Re: CDSP#2022-00024 – Potomac River Generating Station Site
Comment Response Letter to Compiled City Comments for IDSP Concept #2

The Applicant, Hilco Redevelopment Partners (HRP), is in receipt of your comments on their IDSP Concept 2 submission and provides the following responses thereto along with their Completeness Submission filed contemporaneously herewith.

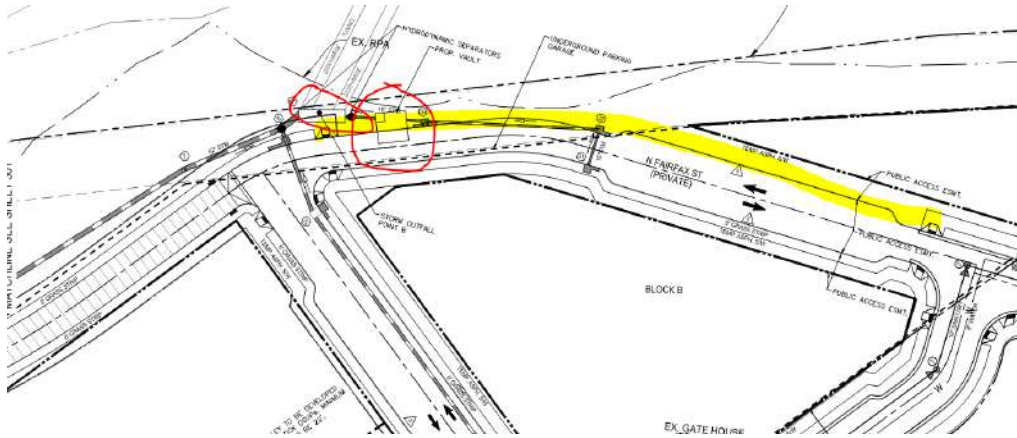
10. Show how a sidewalk or walkway would connect pedestrians from the Slaters Lane/Road A and/or the steps to the Mount Vernon Trail to the east side of N. Fairfax Street by Block E.

Response: Pedestrians have three path alternatives to reach the east side of N Fairfax across from Block E (see image above and Sheets C301&C304). Pedestrians from Slaters Lane/Road A may use the sidewalk around Block F to reach N. Fairfax Street, which provides two ADA connections. Pedestrians may walk from the steps at the terminus of Slaters Lane that connect to the Mount Vernon Trail (MVT) along the trail and path that connect to N Fairfax across from Block E. Connections on NPS property are subject to NPS review and approval.

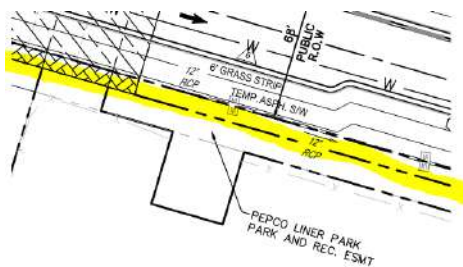
29. Confirm if the kayak drop-off area will remain in same location if the launch area changes.

Response: The proposed kayak launch is located at the most favorable place from a topographical, marine engineering and maintenance standpoint. If a change is necessitated by NPS, the location of the kayak drop-off area may need to be reconsidered.

Figure 1: Delineation of sidewalk zones per the City Complete Streets Guidelines (page 3-3).

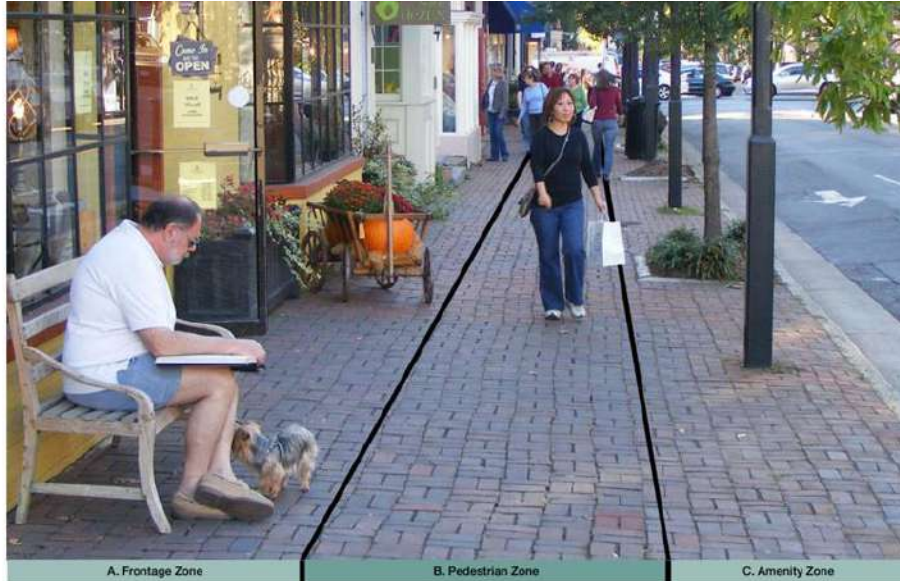
- b. The “pedestrian zone” or main walkway area of sidewalks within private rights-of-way do not count toward open space requirements. However adjacent amenity or frontage zones over 8 feet may be able to count toward open space. Please see the image on the next page.
- c. Provide a proposed outdoor dining exhibit or shade the areas on the open space exhibit (to be updated as needed with subsequent submissions).

- a. **Acknowledged. Please refer to response to Question 31(a) regarding street width.**
- b. **Per the Zoning Ordinance sidewalks adjacent to open spaces that meet the definition for open space are to be included in the calculations for open space.**
- c. **See Sheet A300.**

WOONERF

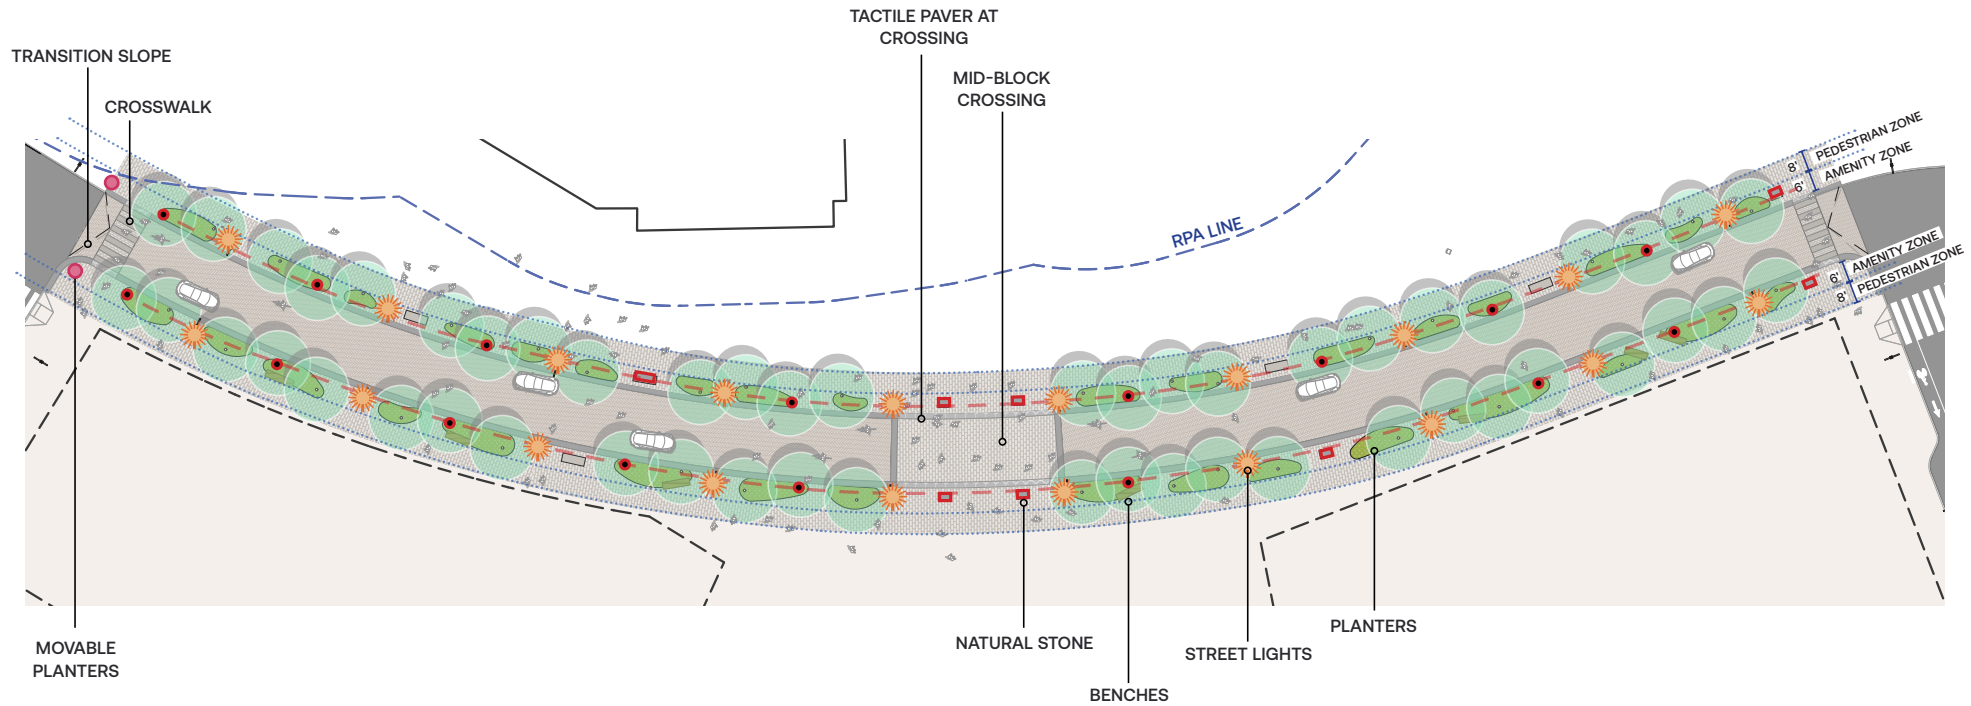
- a. Woonerf design should be a final design since there is no temporary Woonerf design based on the approved Phasing Plan.
- b. Note location of bollards (item 2).
- c. Provide a mid-block crossing adjacent to the Central/Waterfront Plaza that connects to the Pump House.
- d. Provide more details of the final design of the sidewalk adjacent to the Woonerf.
- e. Provide more general details about the pavers (size, material, if permeable).
- f. Show a closer detail on materials and design of the transition slope and crosswalks.

- a. Conceptual Woonerf design is included in the Common Elements Package submitted as Exhibit 1. The final condition of the Woonerf is required to be constructed by the completion of Phase 2 pursuant to Condition 32(a). Final design of the Woonerf will be coordinated with the design and implementation of the Waterfront Park, Block D and the Waterfront Plaza. Proposed details for the Woonerf design, subject to refinement as part of the Waterfront Park, Block D and the Waterfront Plaza DSUPs are included in Sheets L003.

- b. Bollards are not proposed as part of the Woonerf design. Alternative programmatic protection elements will be included in the final design of the Woonerf, please refer to response to 25(a) above.**

EXHIBIT 2

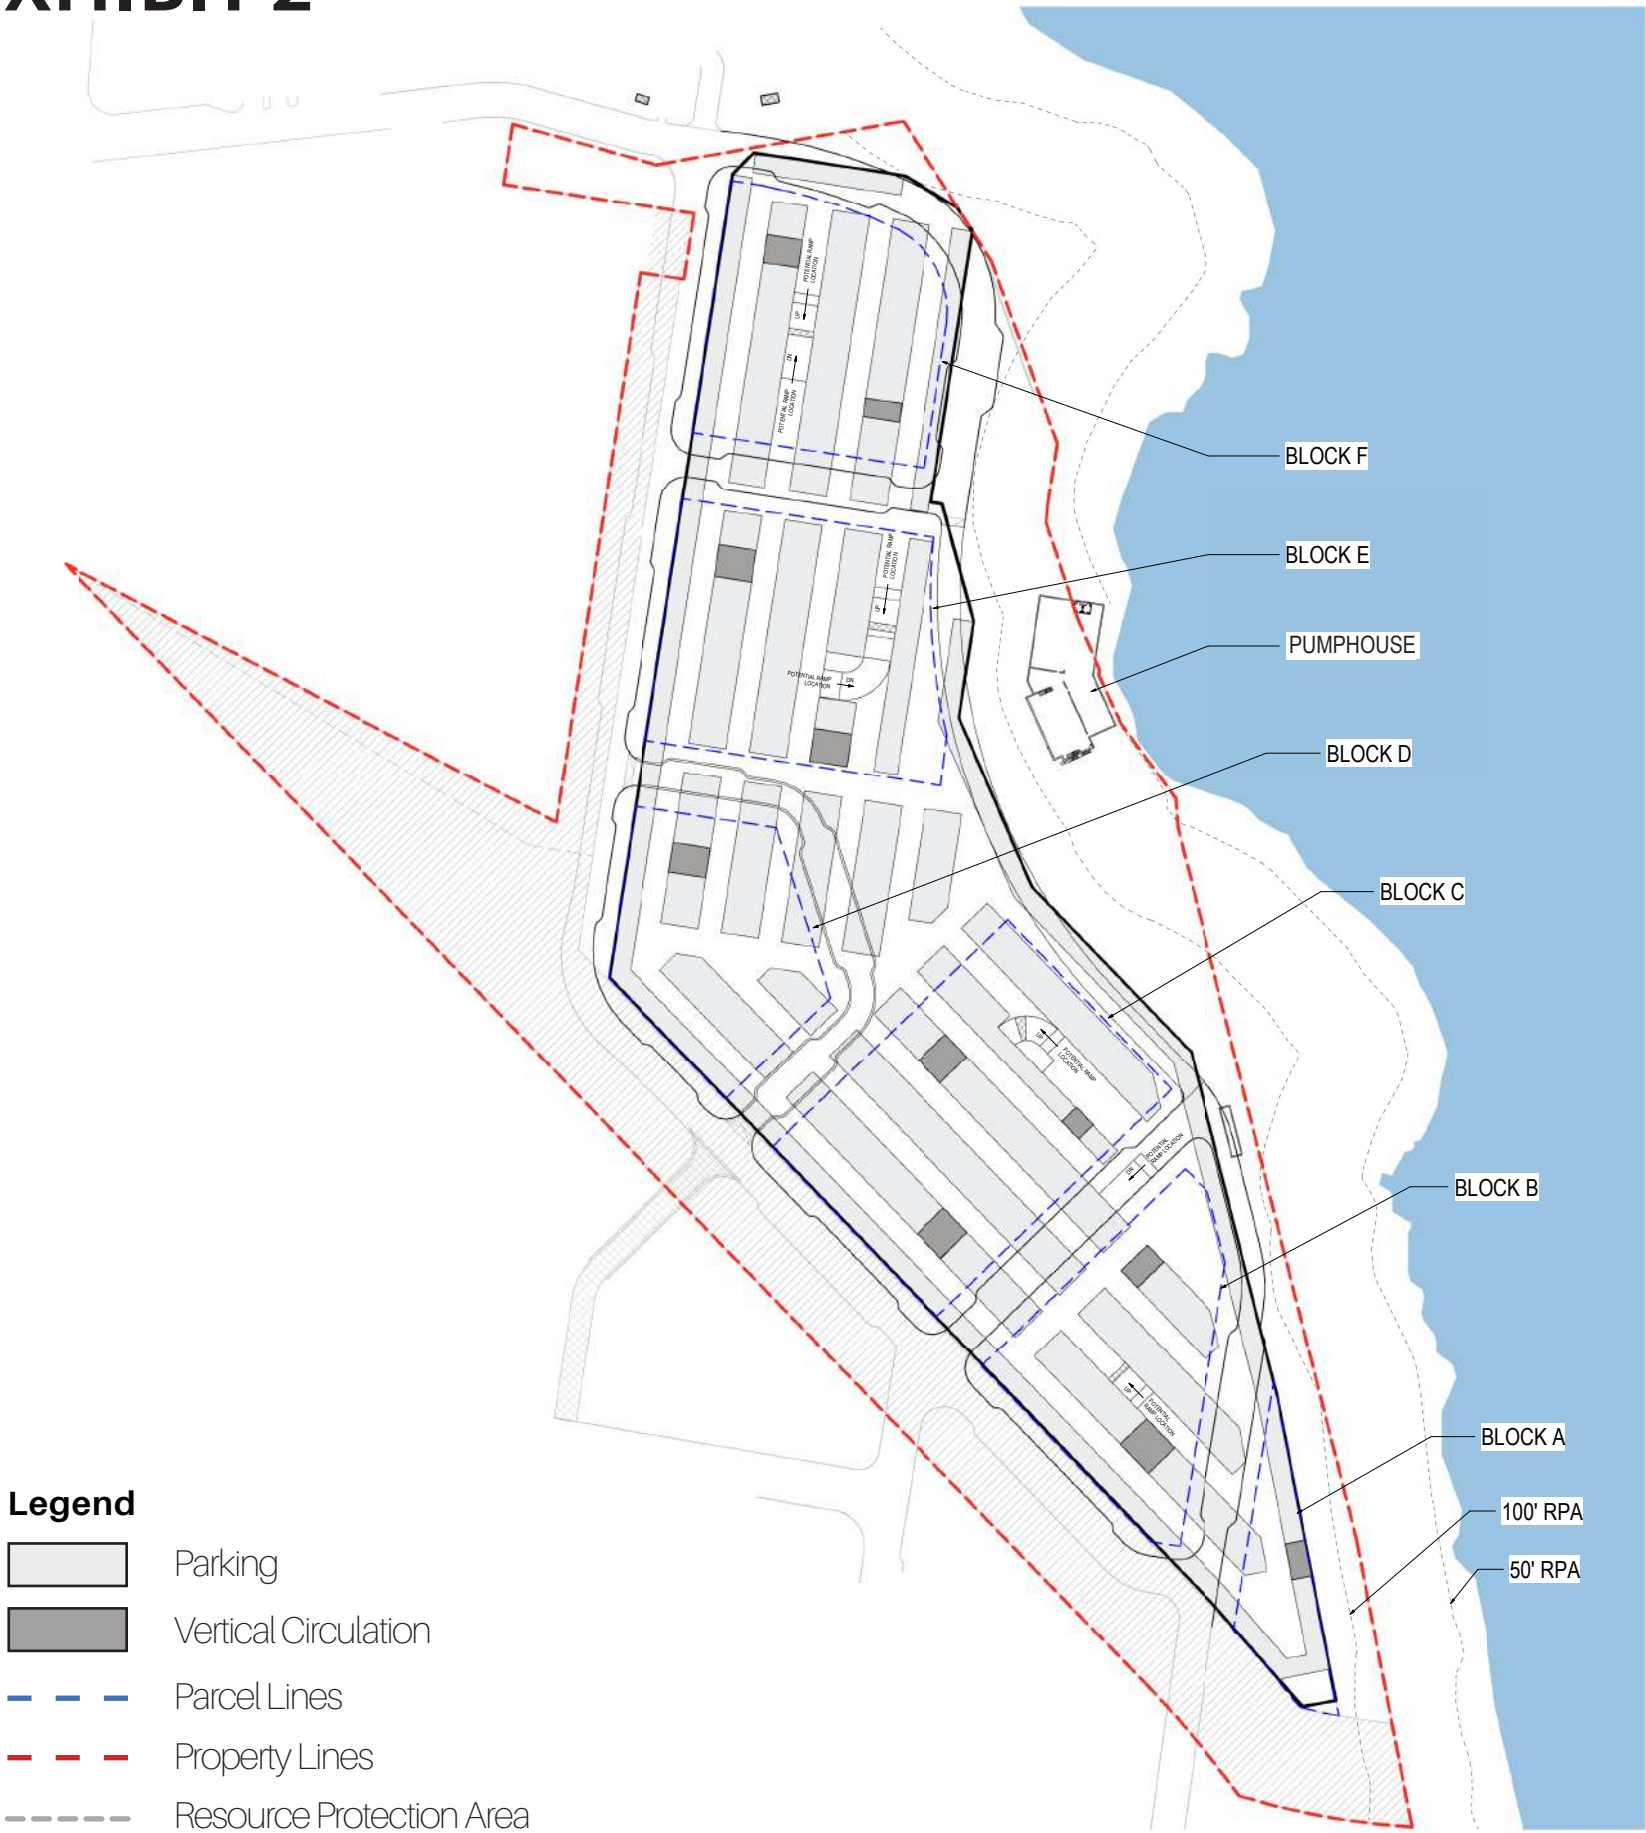
- a. Provide more details on the course and boundaries of the underground garage, specifically near Block E. Staff generally does not support the location of the underground garage within the Waterfront Park space.
- b. An underground parking garage layout exhibit should be provided to demonstrate the overall plan and extent of the garage with approximate entrance locations.

12. The garage footprint is unusual. Provide an exhibit that shows details of the below-grade parking garage. (Transportation Planning)

Response: A conceptual underground parking garage layout is provided on Exhibit 2 of this comment response letter and illustrates the proposed extent and shape of the garage. The garage design depends on the square footage, land use program, and structural grid design of the buildings above the garage and will evolve in parallel

Response: The conceptual layout of the garage is shown on Exhibit 2 to further illustrate the rationale of the shape and extent of the garage, in addition to the general outline shown on Sheet C300. Details of the garage layout depend on the design and program of the vertical structures above including land use program, total square footage, and location of structural column grids. Further details will be provided with each Block DSUP.
